EXSITING PLANS

First floor plan | existing

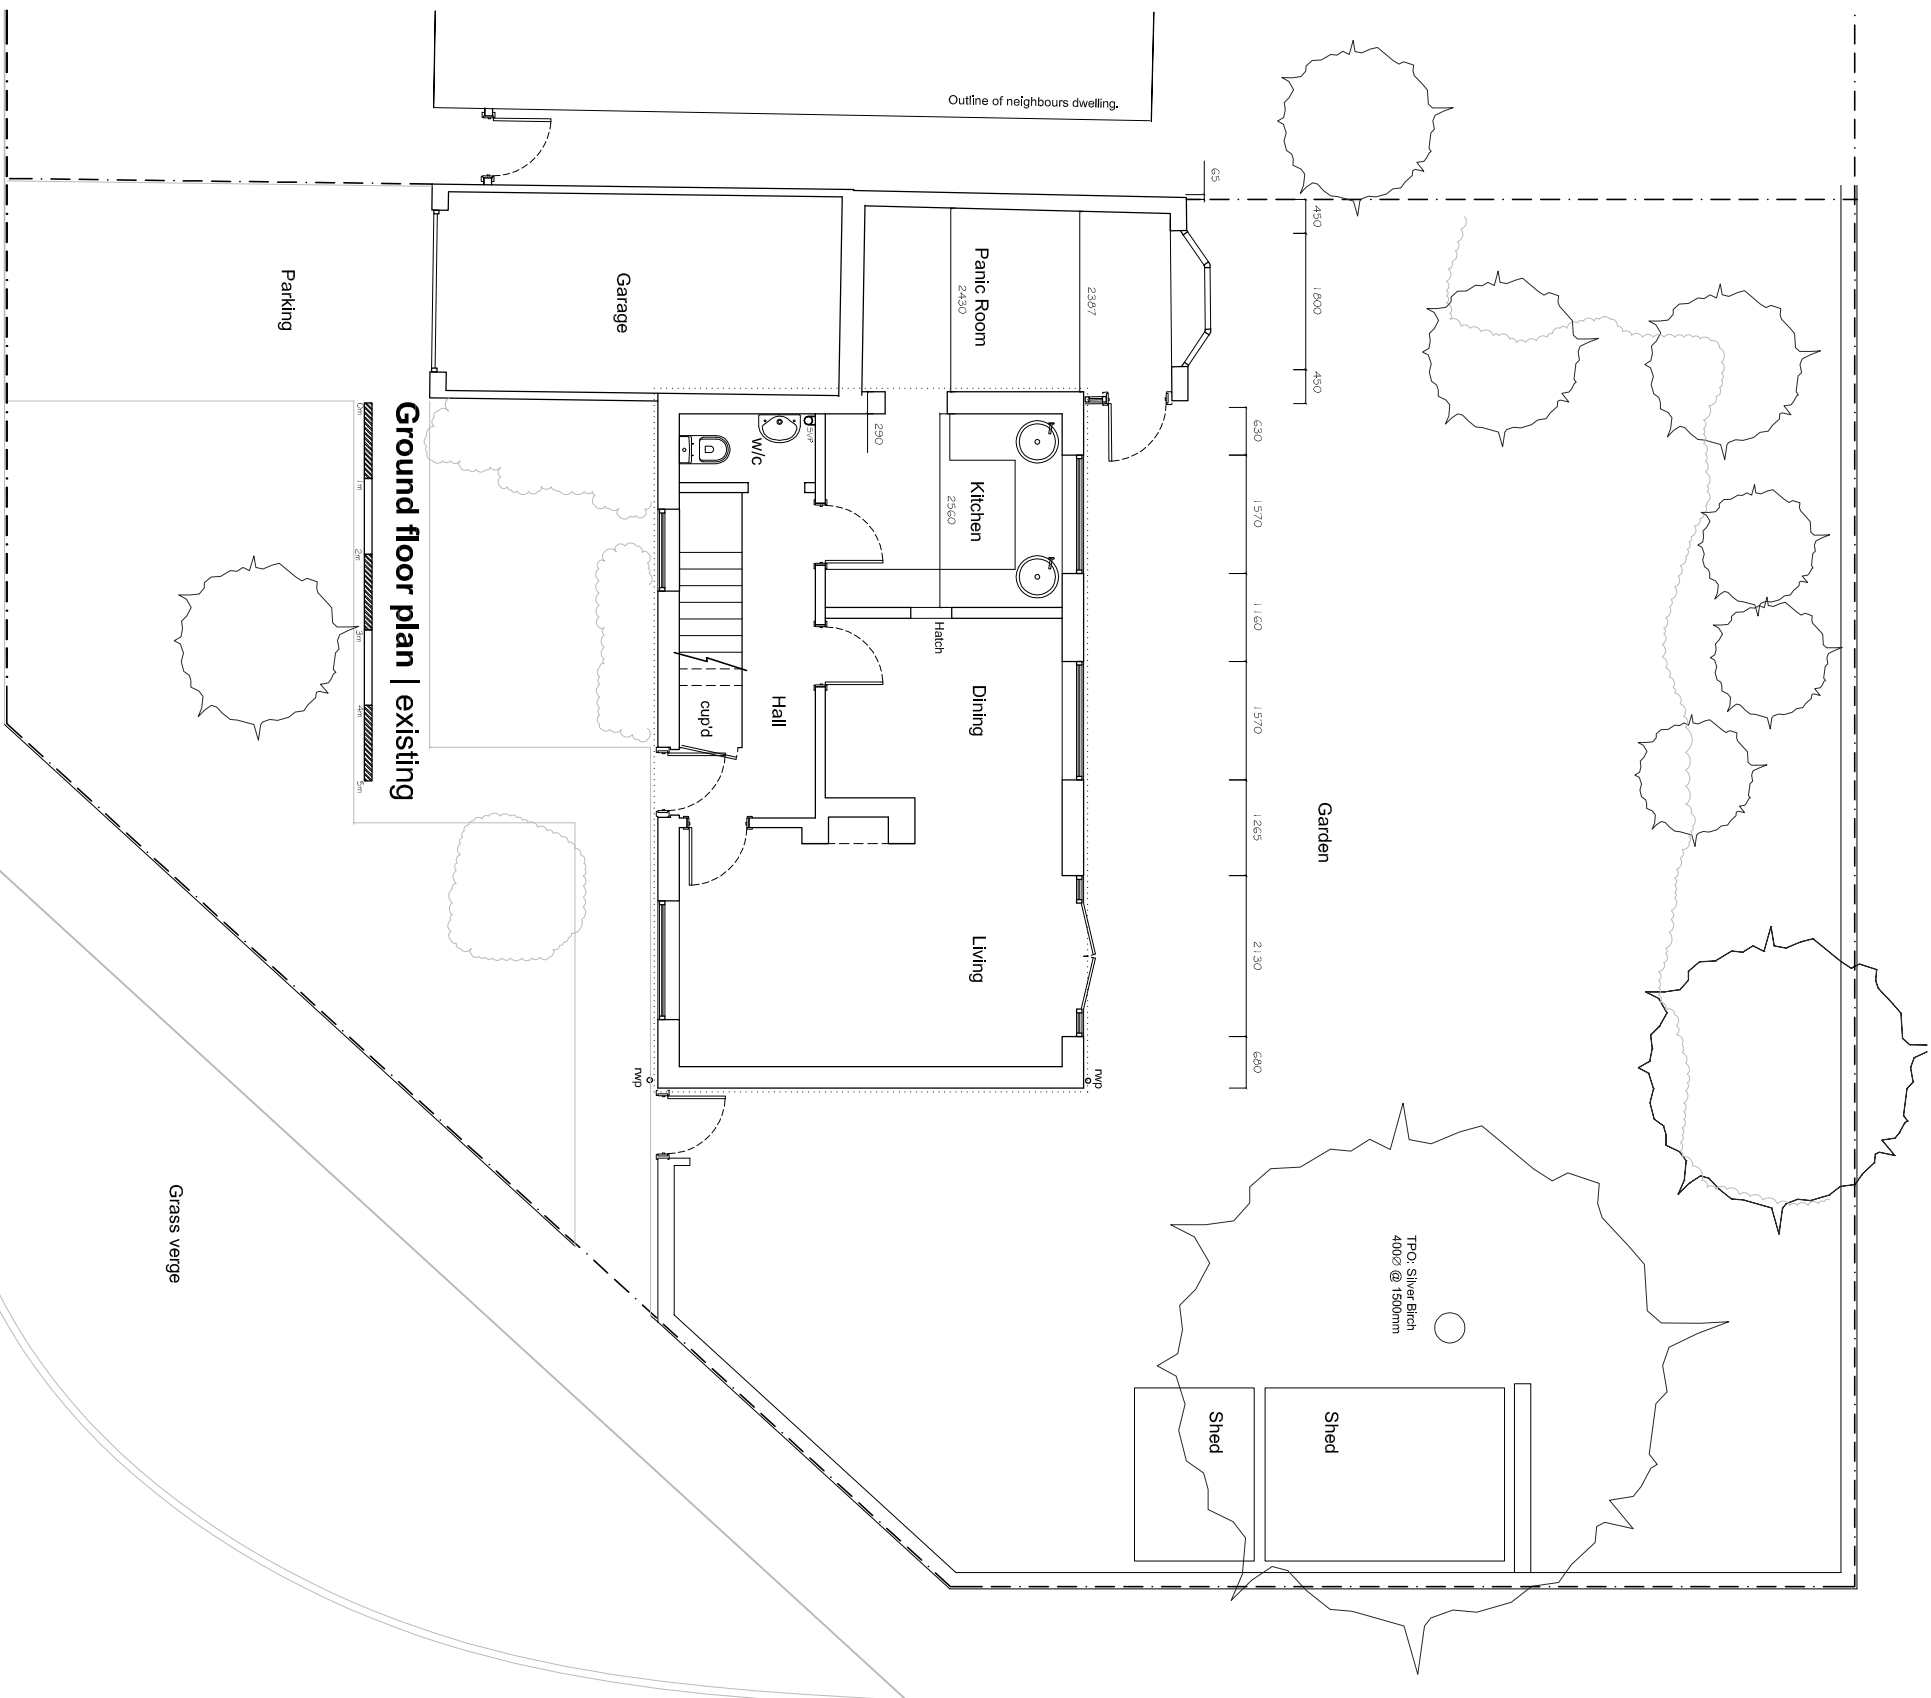
Confirm FF inner wall faces are 50mm set back from GF. Is this because of timber frame detail on upper floor hidden by tile hanging?
